STONEWOOD

PRELIMINARY OVERALL AREA DEVELOPMENT PLAN

RE: Revised Stonewood of Stone Oak Subdivision POADP #387

RE: Stonewood of Stone Oak Subdivision POADP #387

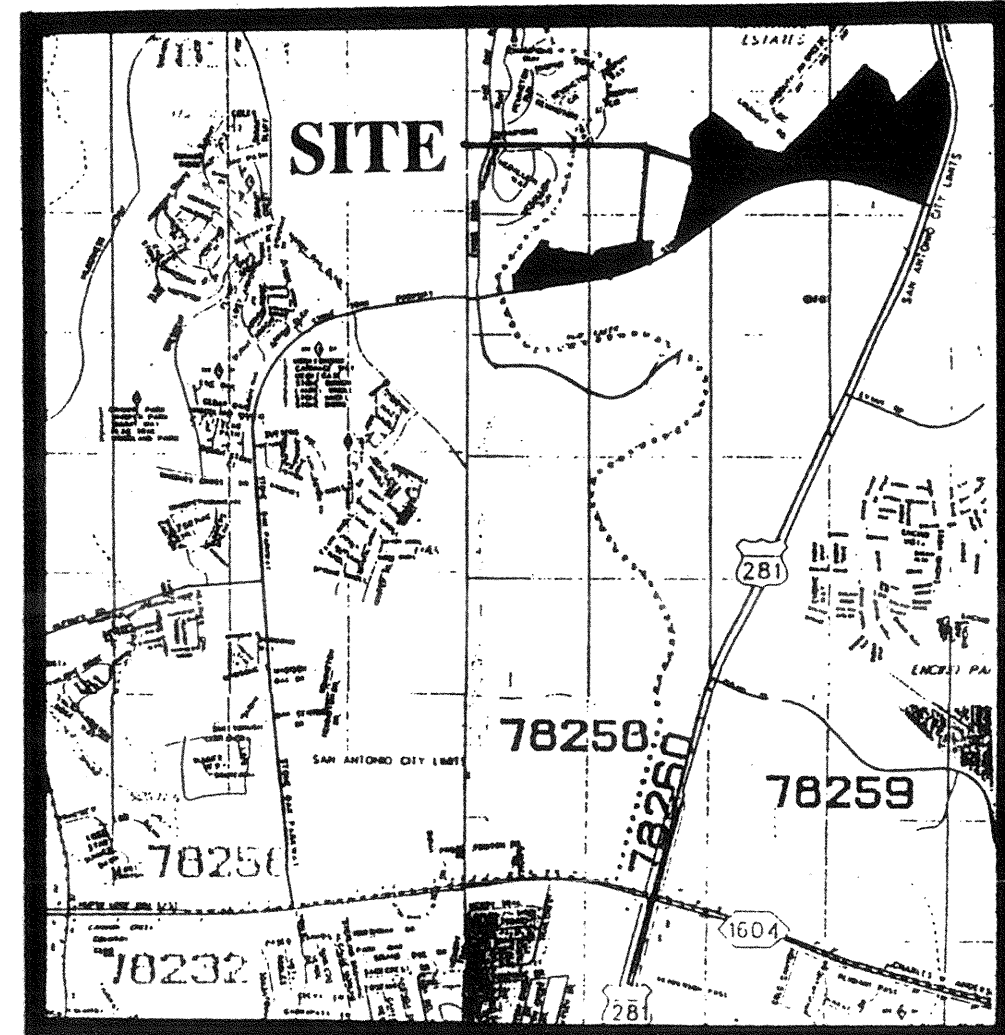
The City Staff Development Review Committee has reviewed your revised Stonewood of Stone Oak Subdivision Preliminary Overall Area Development Plan #387. Please find enclosed a signed copy for your files. You may now submit individual subdivision plat units at your convenience. Although your plan was accepted, please note that a non-access easement will be required along Stone Oak Parkway adjacent to all residential lots.

Additionally, the Traffic Planning Engineer has suggested that the fifty (50) foot access easement be platted as a ROW connecting the two culs-de-sacs as well as providing a similiar connection to the next two culs-de-sacs to the southwest. Otherwise a variance may be required for the access easement at the time of plat submittal.

Your entrances along Stone Oak Parkway appear to be providing for turnarounds and need to be properly aligned with median openings. The Traffic Planning Engineer is requesting additional detail for his review on these entrances.

PRELIMINARY OVERALL AREA DEVELOPMENT PLAN

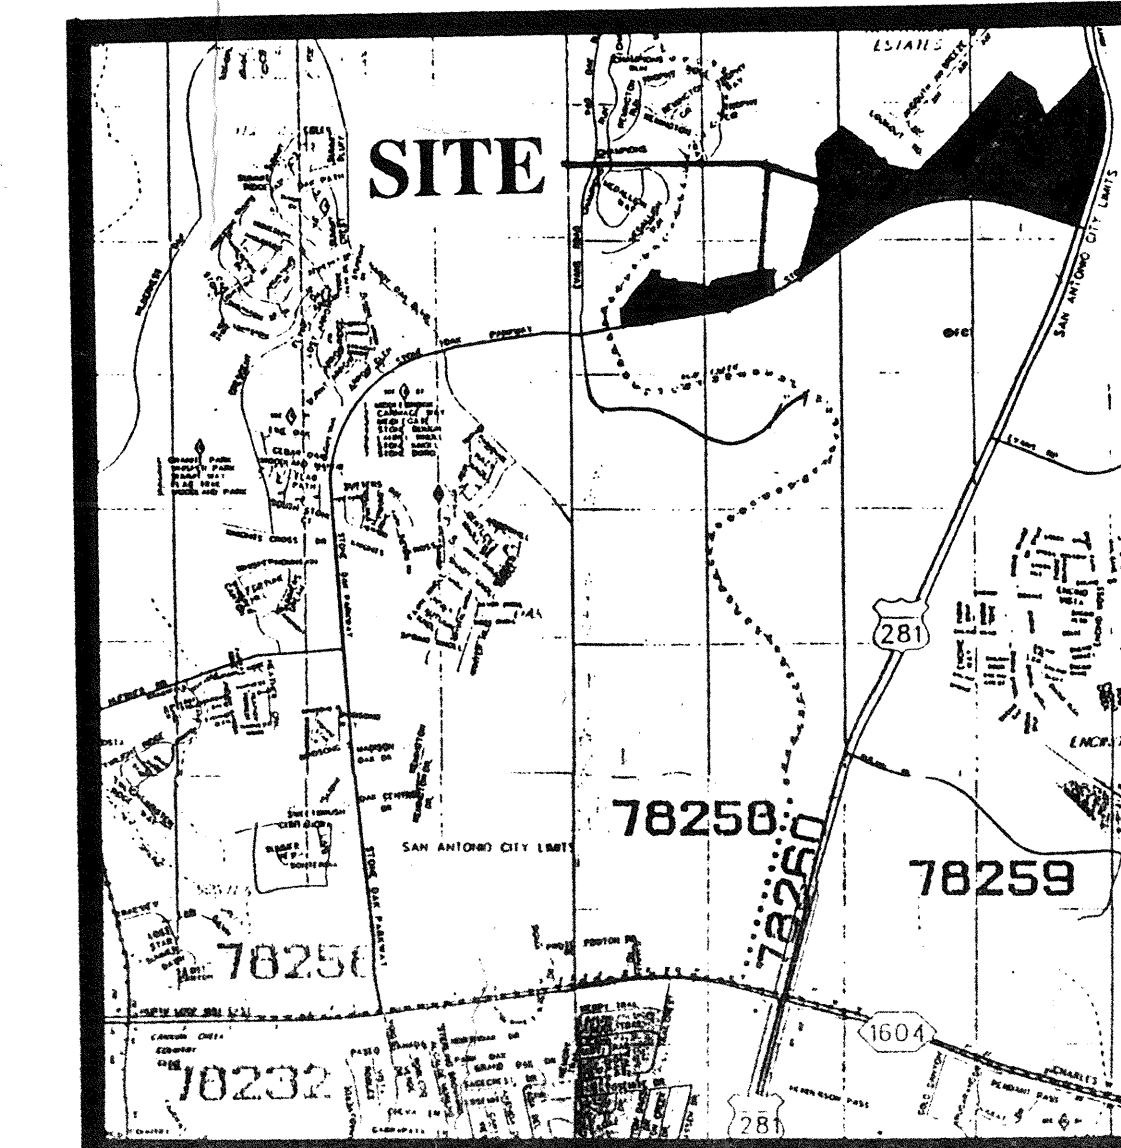
The City Staff Development Review Committee has reviewed your Stonewood of Stone Oak Subdivision Preliminary Overall Area Development Plan #387. Please find enclosed a signed copy for your files. You may now submit individual subdivision plat units at your convenience. Although your plan was accepted, please note that a non-access easement will be required along Stone Oak Parkway adjacent to all residential lots.
